**MONTGOMERY COUNTY HISTORIC PRESERVATION COMMISSION**  
**STAFF REPORT**

<b>Address:</b>	8 Quincy St., Chevy Chase	<b>Meeting Date:</b>	7/10/2019
<b>Resource:</b>	Contributing Resource Chevy Chase Village Historic District	<b>Report Date:</b>	7/3/2019
<b>Applicant:</b>	James Cassidy	<b>Public Notice:</b>	6/26/2019
<b>Review:</b>	HAWP	<b>Tax Credit:</b>	N/A
<b>Case Number:</b>	35/13-19BB	<b>Staff:</b>	Dan Bruechert
<b>Proposal:</b>	Demolition and New Construction

**STAFF RECOMMENDATION**

Staff recommends that the HPC **approve** the HAWP application.

Rear Elevations

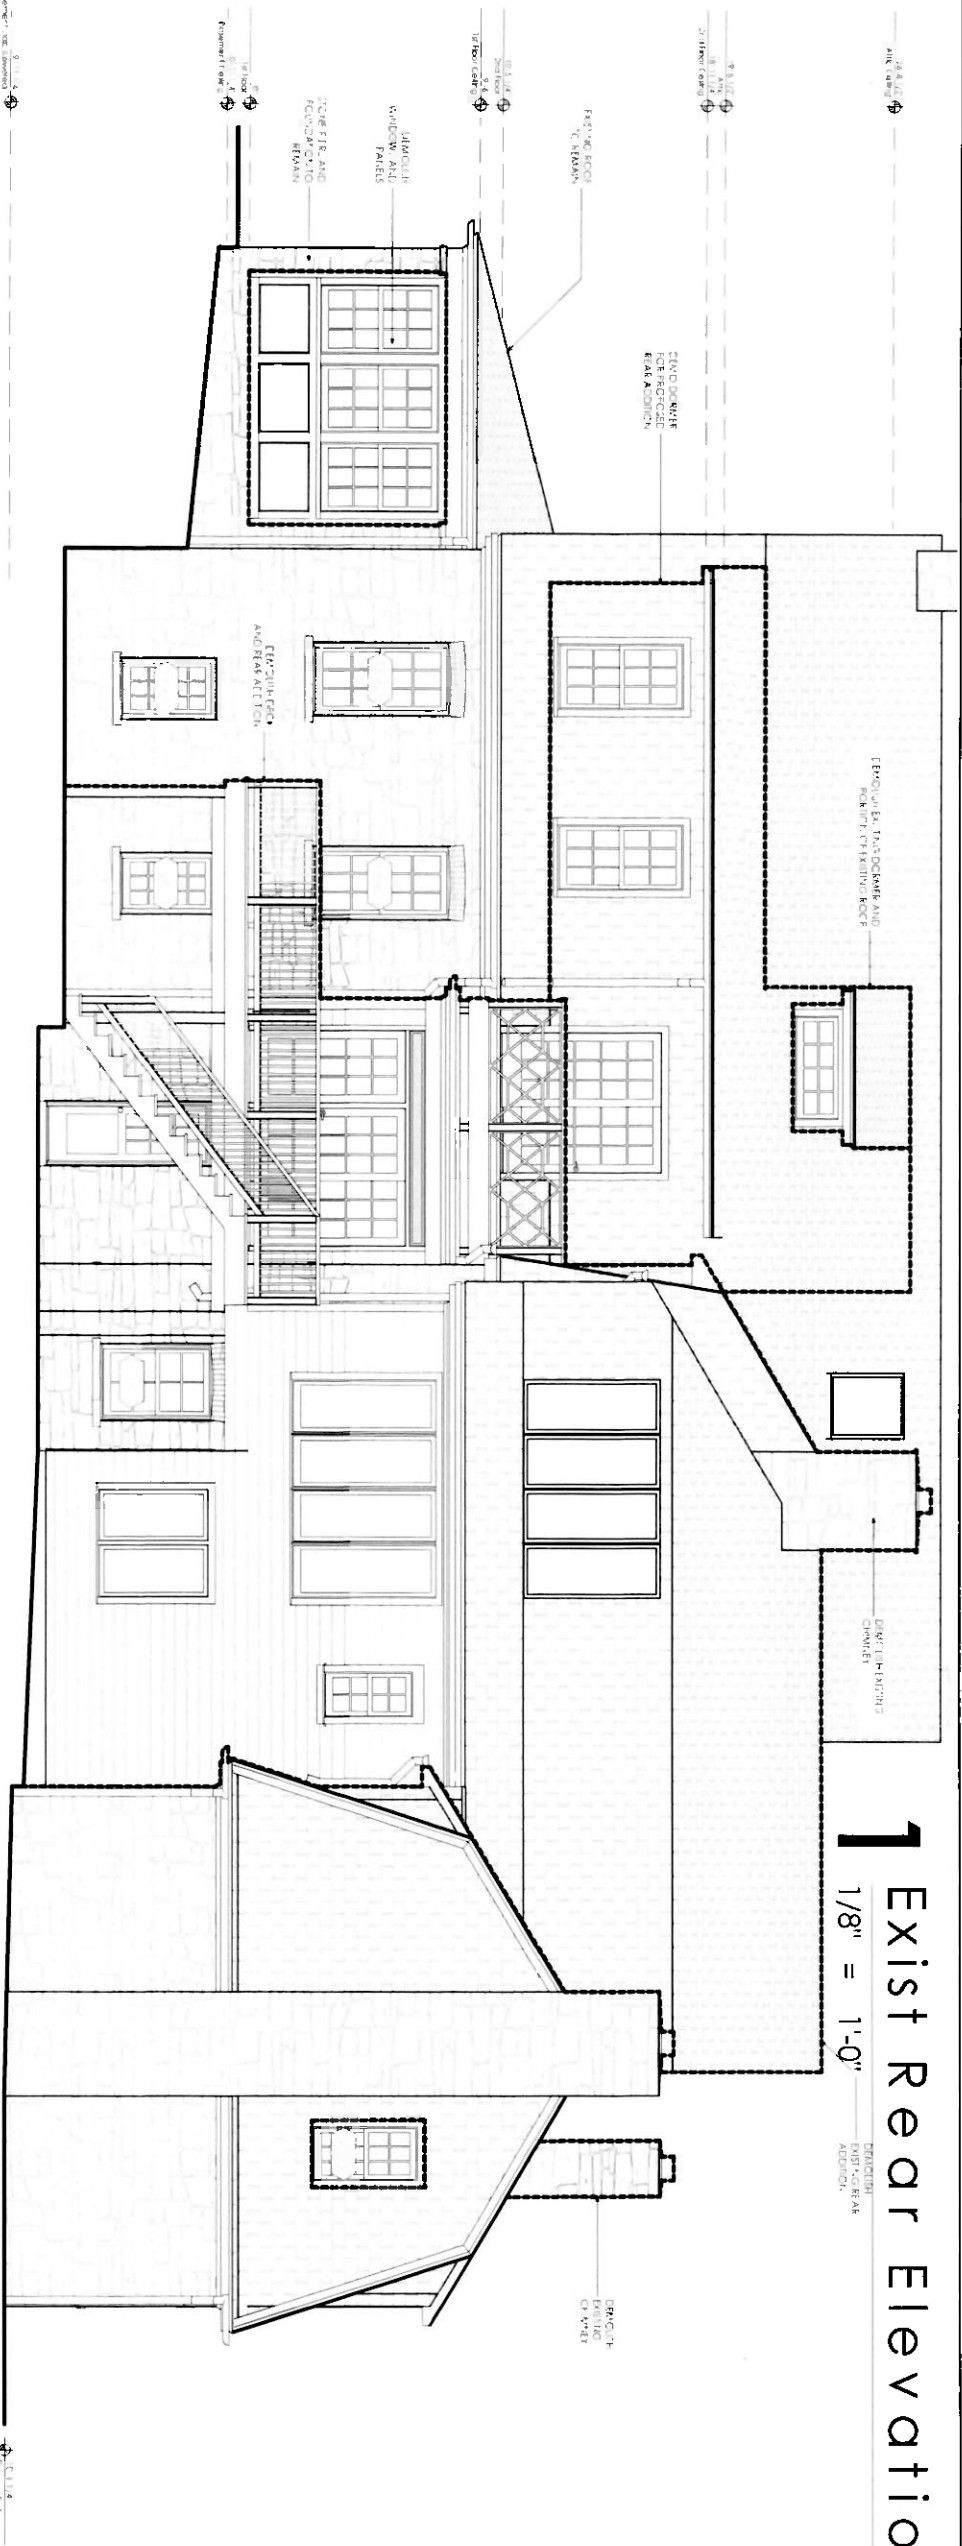
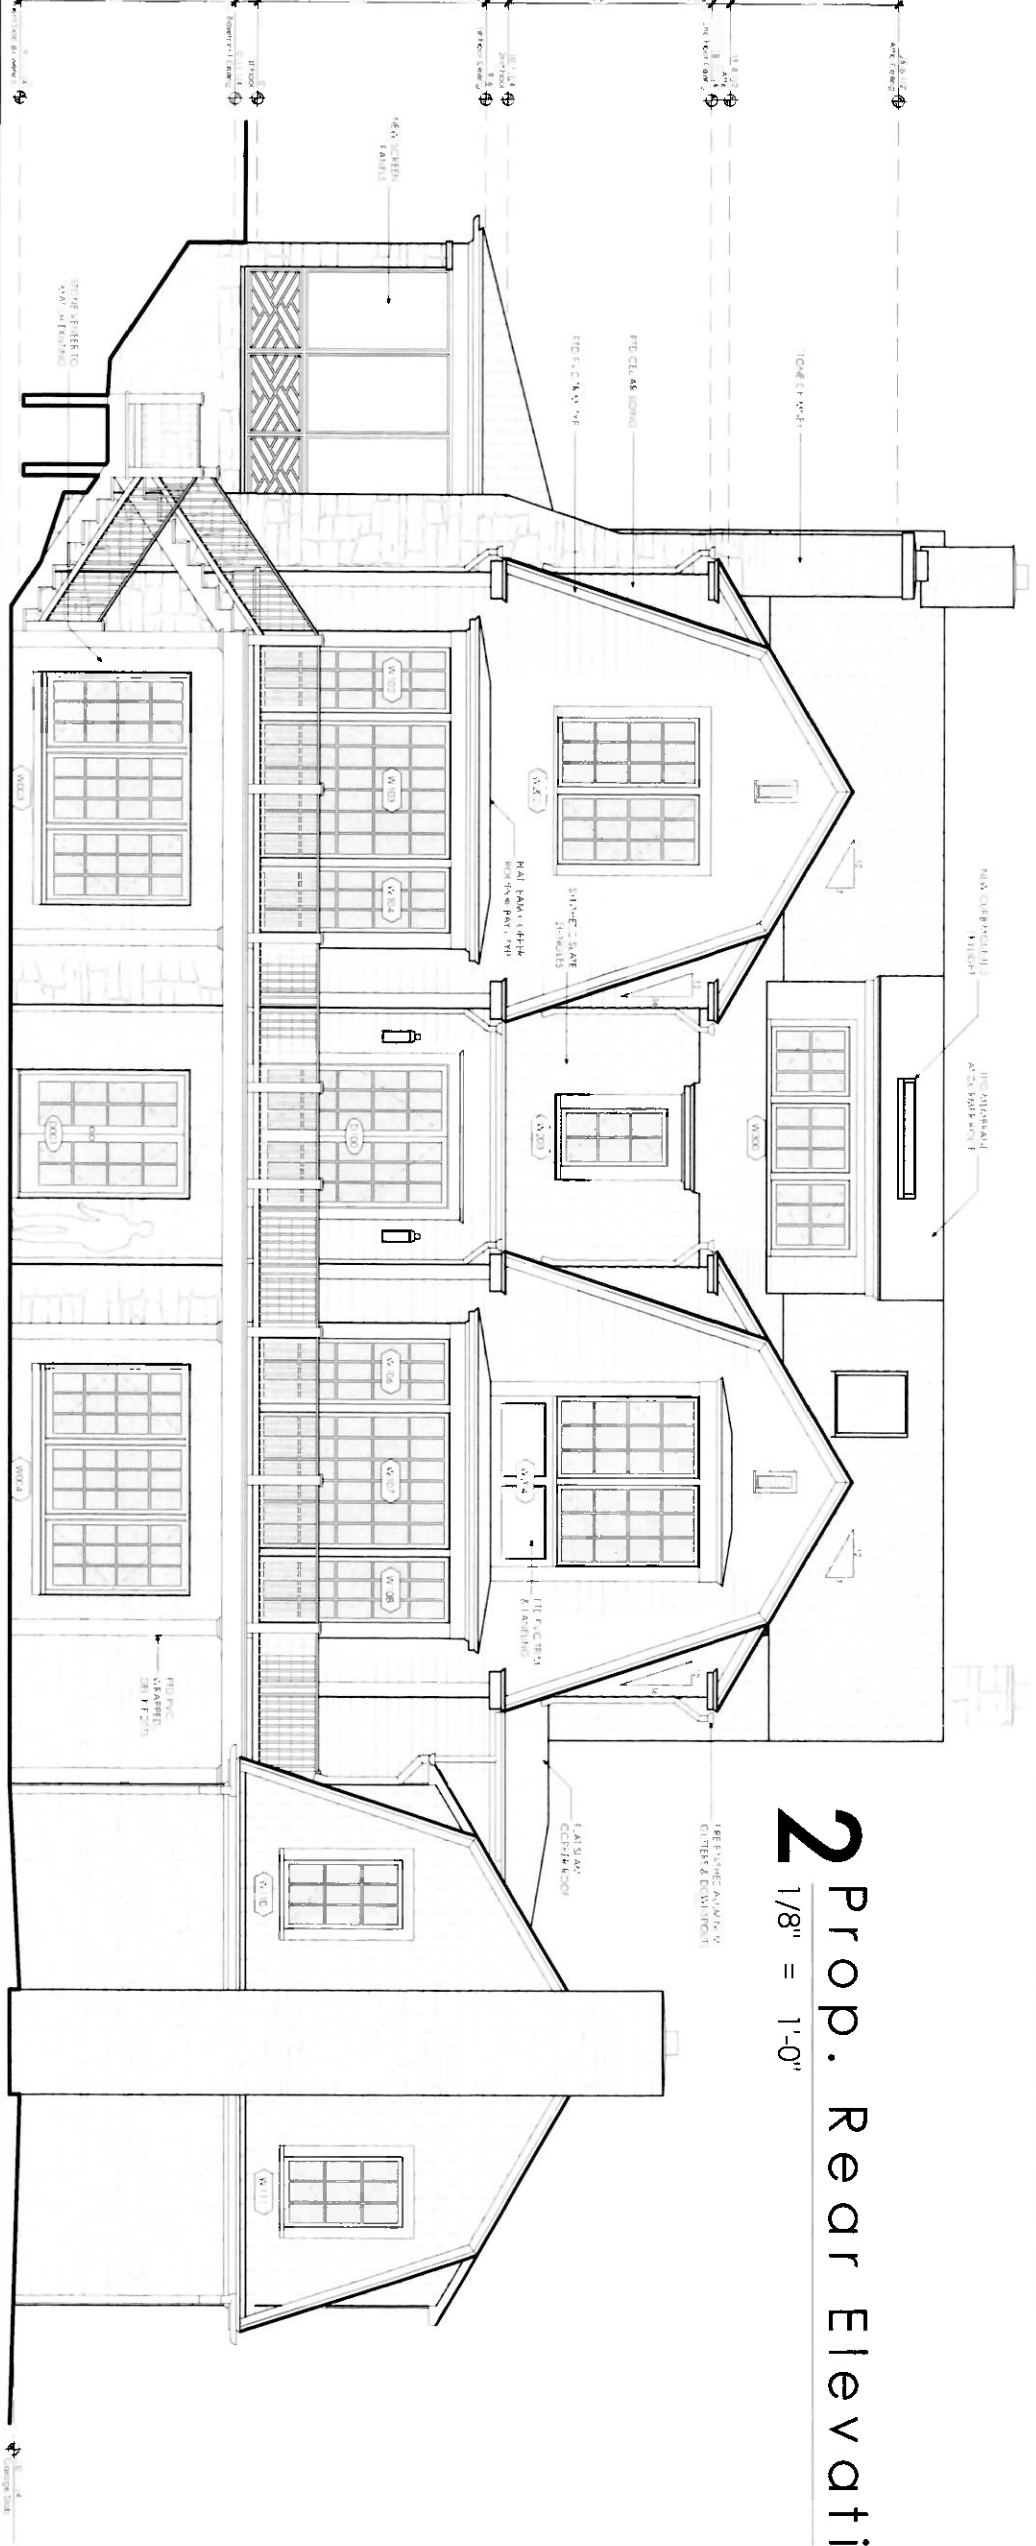
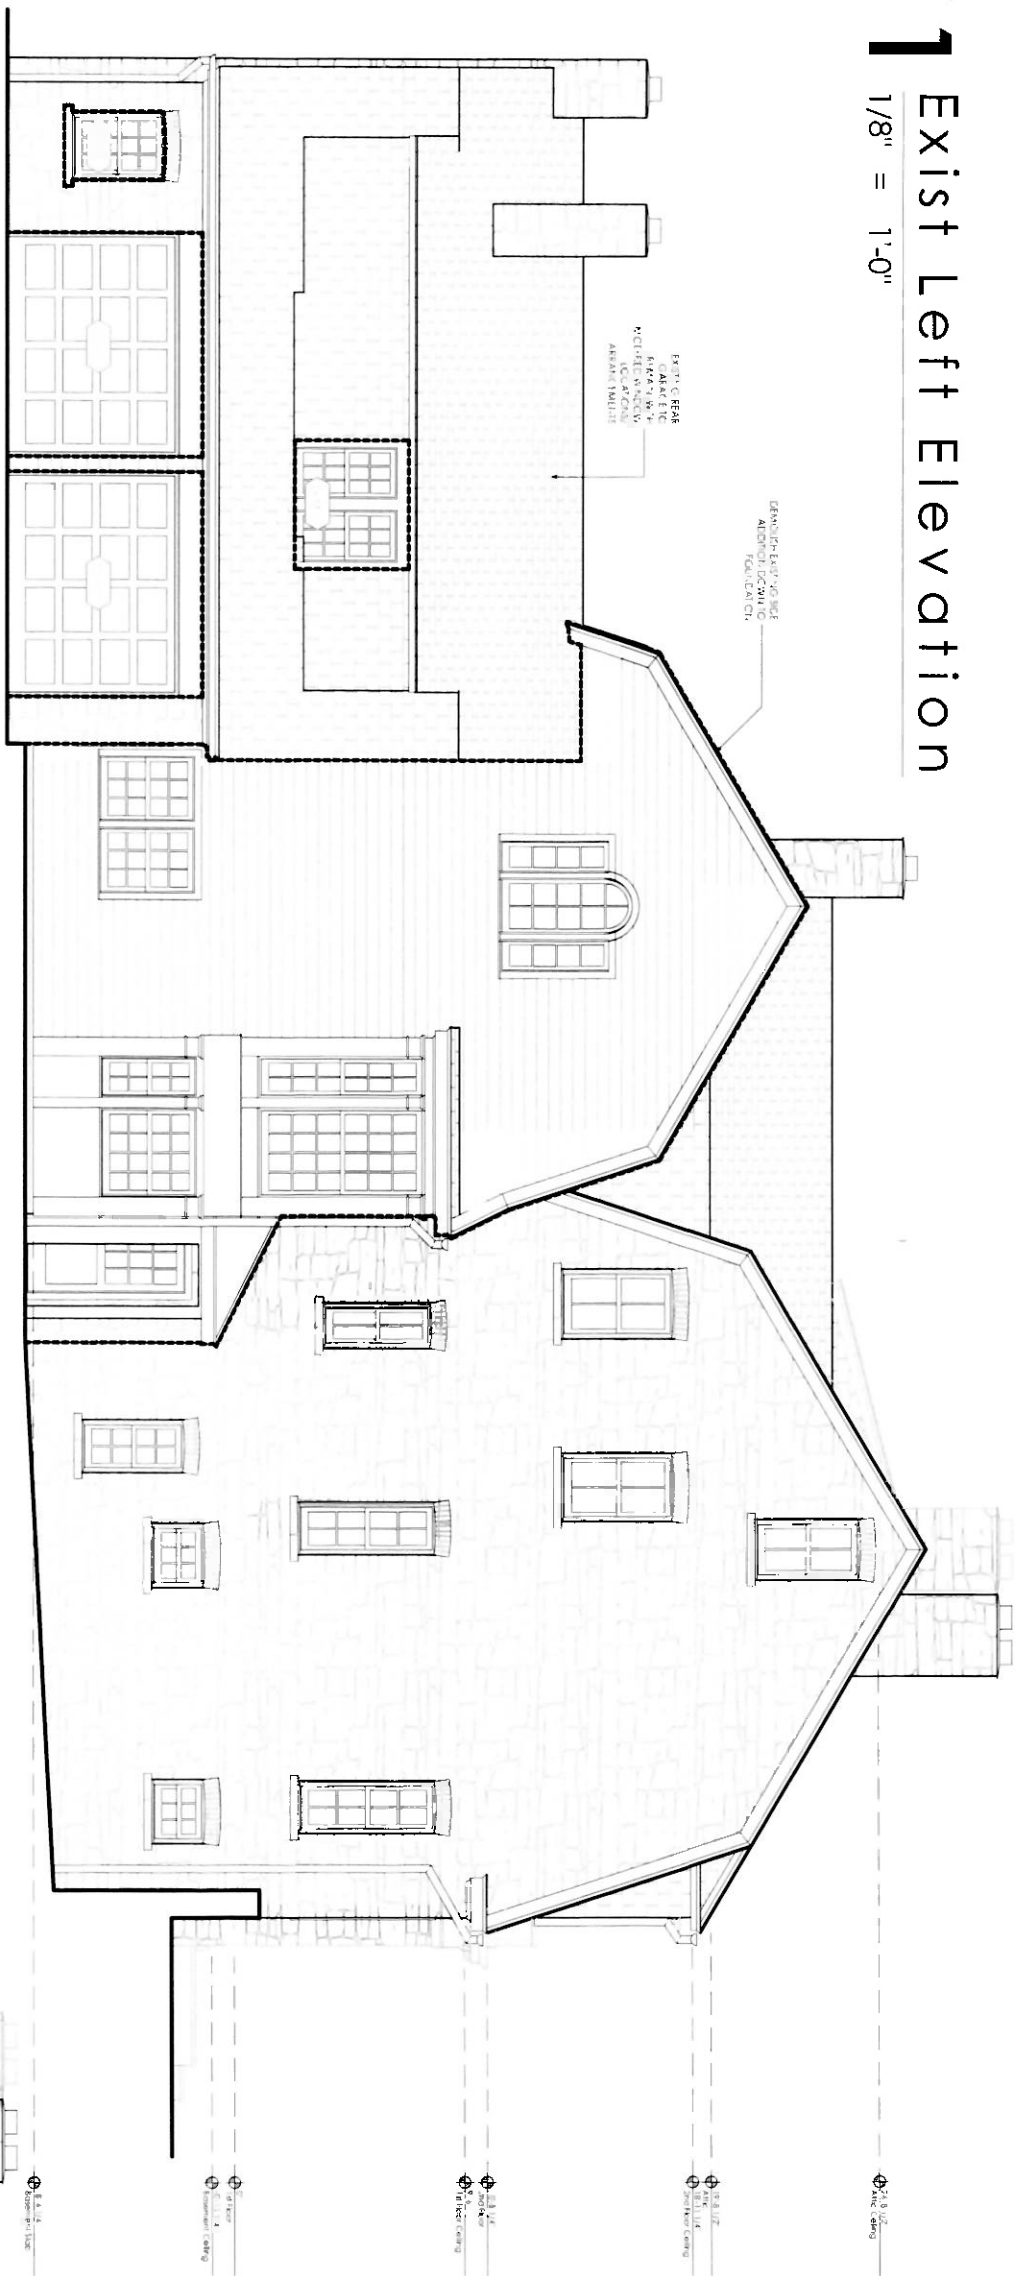
At the rear, the applicant proposes to construct a nearly, full-width addition with a pair of rear facing gambrel roofs covered in synthetic slate roofing. The addition will be inset from the historic wall planes by approximately 2' (two feet). The basement level of the proposed addition will be clad in a stone veneer to match the historic house, with the first and second floor clad in painted cedar siding. Staff finds the proposed exterior material sufficient to differentiate the new construction from the historic (per Standard 9). The proposed roof at the rear will have an EcoStar Majestic Slate, synthetic roofing material. This roof will be partially visible from the right-of-way and subject to "moderate scrutiny." The *Design Guidelines* go even further, stating, "in general, materials differing from the original should be approved for contributing resources." Staff finds that the proposed material for the roof over the proposed addition is compatible with the historic building for two primary reasons. First, because Staff finds the appearance of the proposed replacement material is an appropriate substitute for replacement on new construction or additions (per the *Design Guidelines*); and second, because the addition roof will only be minimally visible from the public right-of-way (see the submitted perspective drawings), limiting its impact on the historic resource and surrounding historic district.

There are two additional elements proposed for the rear addition that warrant discussion. The first is a proposed shed dormer at the rear. This dormer will have a low-sloped shed roof in a membrane roof, with a skylight and three rear-facing casement windows. Staff finds this feature will not be visible from the public right-of-way and, per the *Design Guidelines*, should be reviewed under lenient scrutiny. Staff finds that the scale and massing of the proposal is appropriate and will not impact the surrounding streetscape and recommends approval for the proposed dormer. The other new feature proposed for the rear addition is the introduction of a new chimney on the right (west) elevation. The chimney will be clad in a veneer to match the existing house foundation. The *Design Guidelines* do not provide guidance on what level of scrutiny to review chimneys, however, they do state that review should be undertaken in a manner that is consistent with the two paramount principles for the district, “fostering the Village’s shared commitment to evolving eclecticism” and “maintaining the open, park-like character.” Staff finds that the proposed chimney will not negatively impact either of these principles and recommends approval of the chimney under the *Design Guidelines* 24A-8(b)(2).

Staff finds that the proposed rear addition demolition and new rear addition are consistent with the *Design Guidelines*, Standards 9 and 10, and 24A-8(b)(2) and recommends approval.
